VIRTUAL MEETING OF THE BIRMINGHAM PLANNING BOARD
WEDNESDAY, JANUARY 27, 2021
7:30 PM

SUBJECT: 856 N. Old Woodward – Fruition – Special Land Use Permit & Final Site Plan Review

FRUITION SPECIALTY FOOD STORE

FLOOR PLAN
SCALE: 3/8" = 1'
NORTH

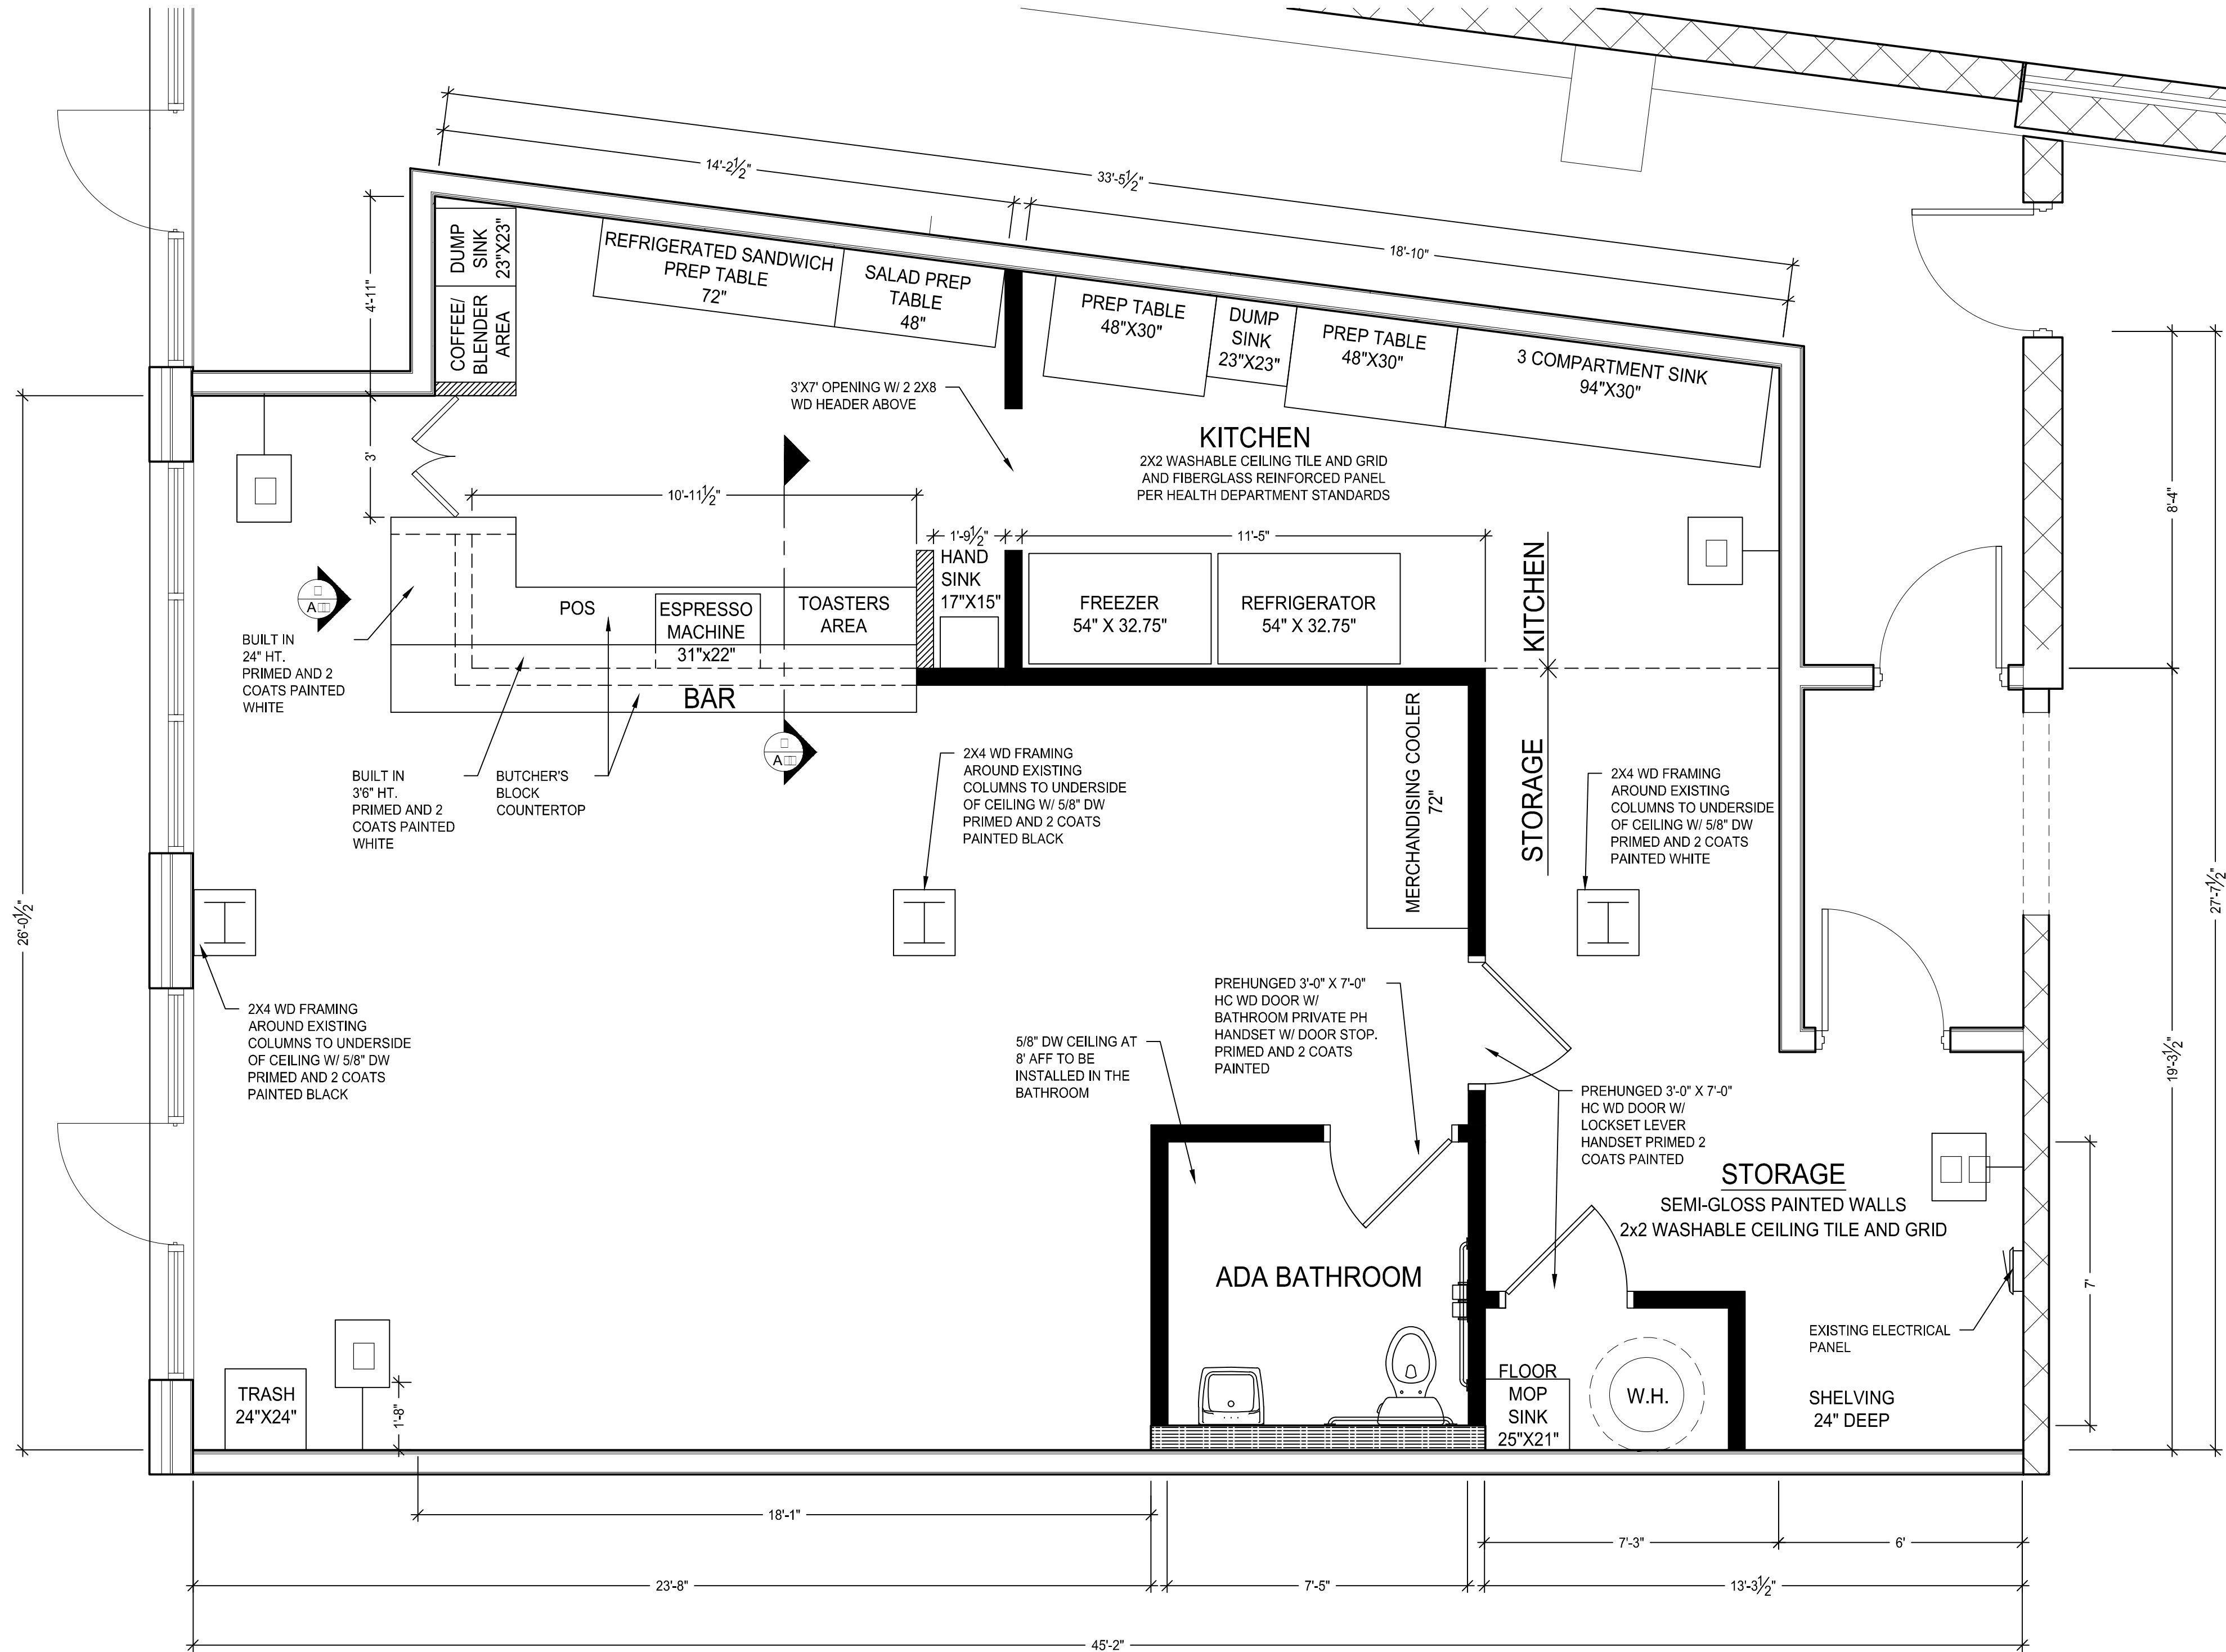
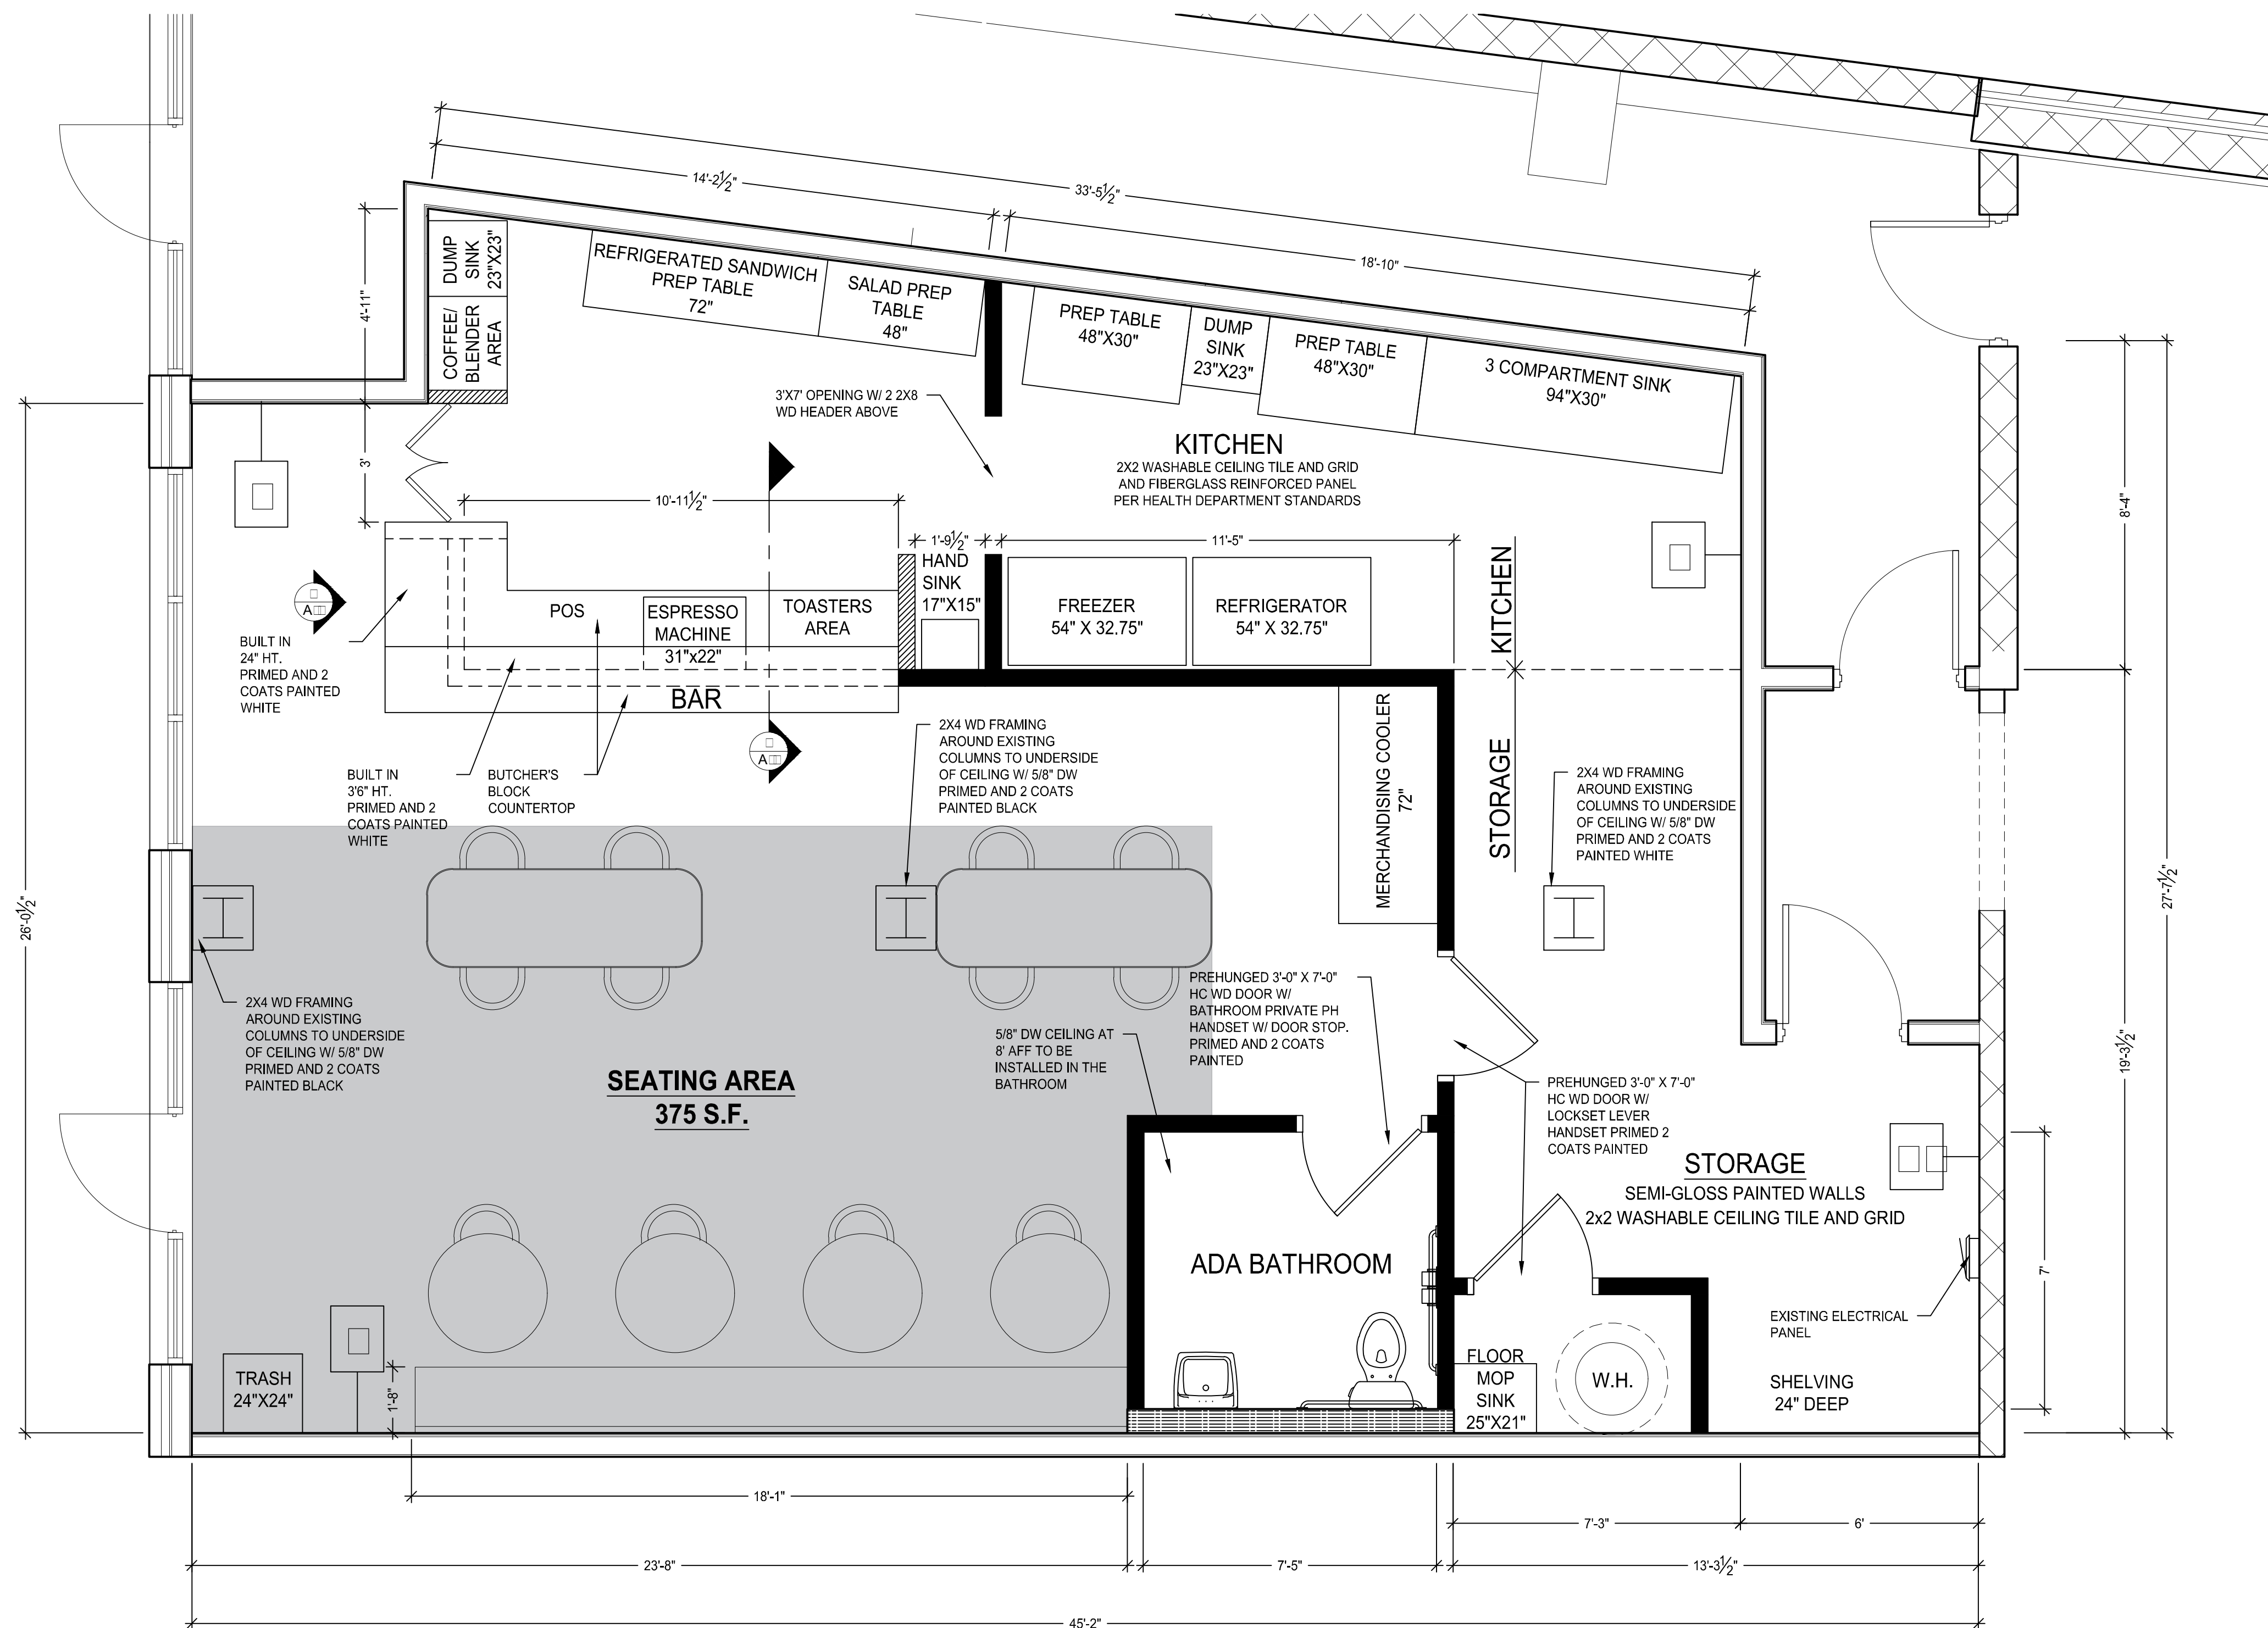
The proposed new restaurant, Fruition, plans to serve fast healthy foods including smoothies, acai bowls and an assortment of drinks. The proposal includes the kitchen in the rear, a service counter, and a total of 12 chairs; 8 located at two tables and 4 located at a high top counter in a dining area at the front of the building. There are no outdoor seats proposed at this time.

The first approved tenant for the building was Lash Lounge Salon which currently requires 14 parking spaces. The second approved tenant Fruition currently requires 4 spaces – creating a total requirement of 18 parking spaces which the building currently satisfies. An application for a third tenant, Aurora Medi-Spa, is currently pending due to submitted plans proposing 5 service chair stations requiring 10 parking spaces, though only 5 parking spaces remain for that tenant space.

There are a number of variables impacting Fruition's ability to satisfy the parking requirements of the Zoning Ordinance. The subject's application is currently impacted by the uses and submitted floor plans of the other two tenants in the building's commercial space. Hypothetically, if the City Commission approves the 5 on-street spaces to be included in the parking requirement count, The Pearl would then have 28 parking spaces for commercial uses. If the two neighboring tenant spaces were vacated and re-occupied as retail uses, they would require 10 of the 28 commercial parking spaces and Fruition could then satisfy the parking requirement because more than 16 spaces remain. Fruition's current inability to meet the parking requirement is impacted by the other two tenant spaces, however, the uses and floor plans of the other two tenants could change at some point in the future and provide the ability for Fruition to satisfy their parking requirements.

Given the shortage of parking spaces for the building, it does not appear that the applicant satisfies the approval criteria for Site Plan Review and Special Land Use Permit applications. However, the Planning Divisions finds the ability to satisfy the approval criteria could change based upon updated floor plans and future tenant uses.

Based on a review of the site plan submitted, the Planning Division recommends that the Planning Board **POSTPONE** a recommendation to the City Commission of the Special Land Use Permit and Final Site Plan for 856 N. Old Woodward – Fruition. The purpose of the postponement is to provide an opportunity for the building owner and all three commercial tenants to consider reaching an agreement where all tenants involved satisfy the requirements of the Zoning Ordinance and have submitted acceptable updated floor plans with new occupancy permits signed by the tenant representatives who acknowledge any changes.
